Range Control  
Marine Corps Base  
Camp Lejeune, North Carolina 28542

Subj: SAFETY DEFICIENCIES: BASE RIFLE RANGE

Figure B-3 Record firing range - M16

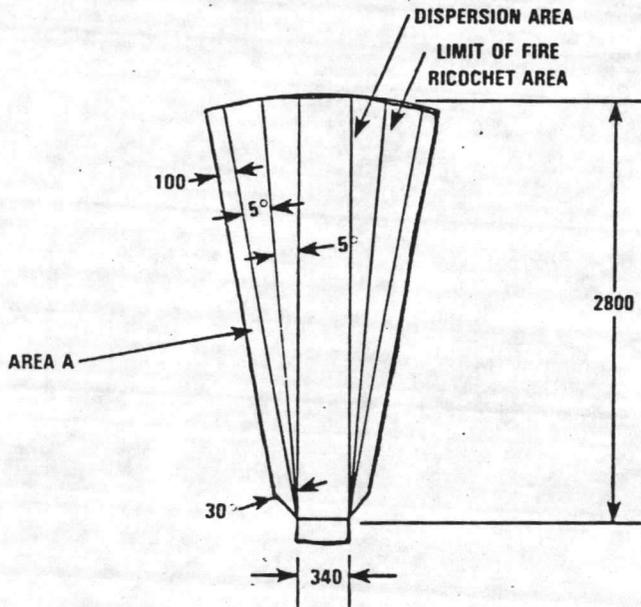
b. A quick fix completed this week by Range Maintenance has been the emplacement of two range warning flag poles at grids vic 764305 and 759321. The Rifle Range must raise and lower red warning streamers from these poles to coincide with actual firing times. To fly streamers continuously, 24 hours a day would be contrary to the requirements of references (a) and (b). Enclosure (1) depicts the SDZ.
